ADVANCED GEOTECHNICAL SOLUTIONS, INC.

March 28, 2022
PW 1912-01
Report No. 1912-01-B-6
City of San Diego Project No. 698277

Subject: **Geotechnical Addendum and Response to LDR-Geology Cycle 2 Review Comments, Multifamily Residential Development, 555 Hollister Street, San Diego, California**

PLATE 1

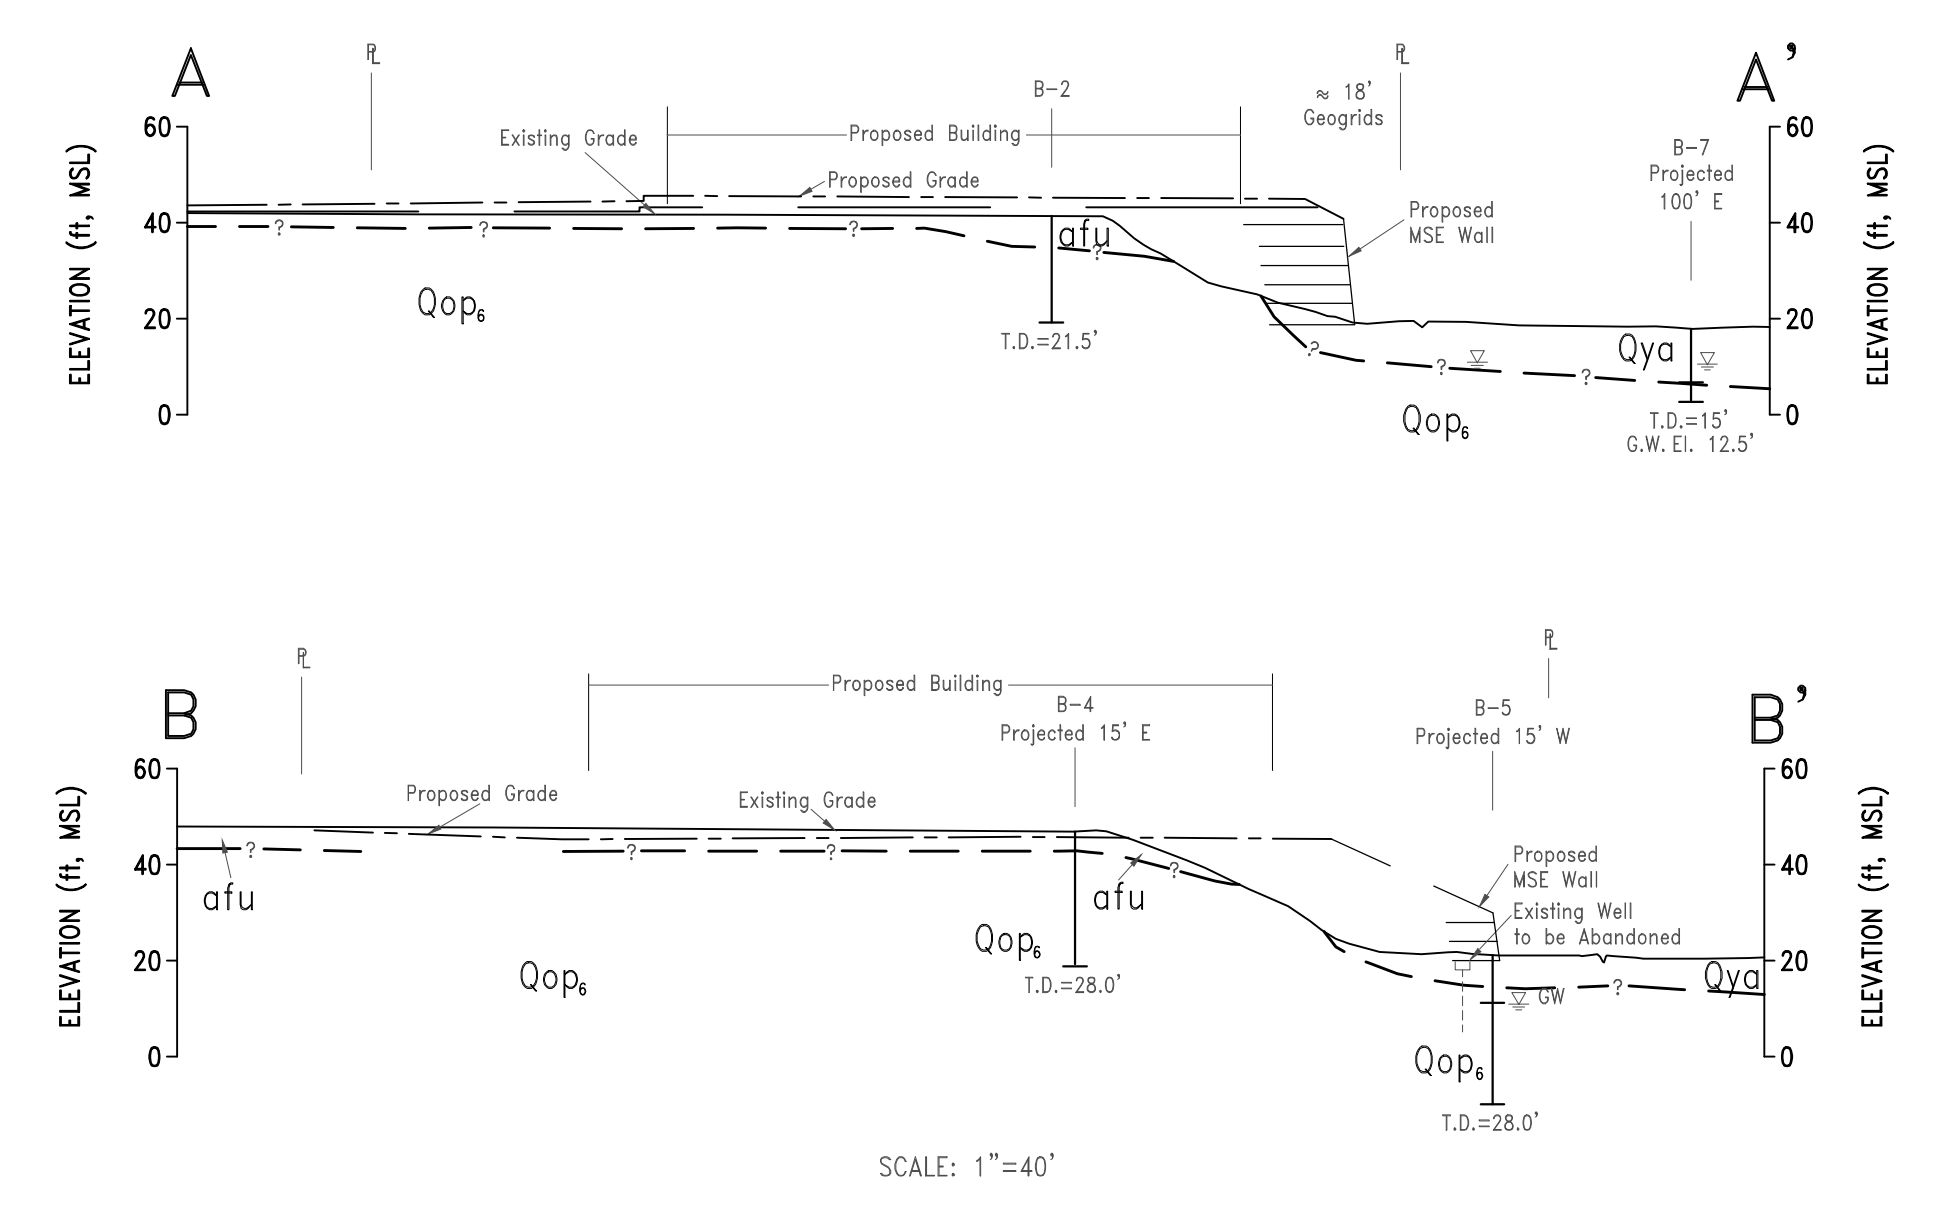
Item 3 -City of San Diego- *The geotechnical consultant must indicate if the site is suitable for the proposed development as designed or provide recommendations to mitigate the geologic hazards to an acceptable level.*

AGS Response - AGS has updated the attached Plate 1, Geologic Map and Exploration Location Plan showing the exploratory locations, site geology, and geologic cross sections using the current Grading and Drainage plan (Sheet C005) by Pasco Laret Suiter & Associates (PLSA) dated November 10, 2021 as a base map. Based on our review of the current grading plan, the site is suitable for the proposed development as designed. The referenced geotechnical report by AGS (2021a) provided recommendations that should be incorporated into the design and construction of the project and will mitigate the site geologic hazards to an acceptable level.
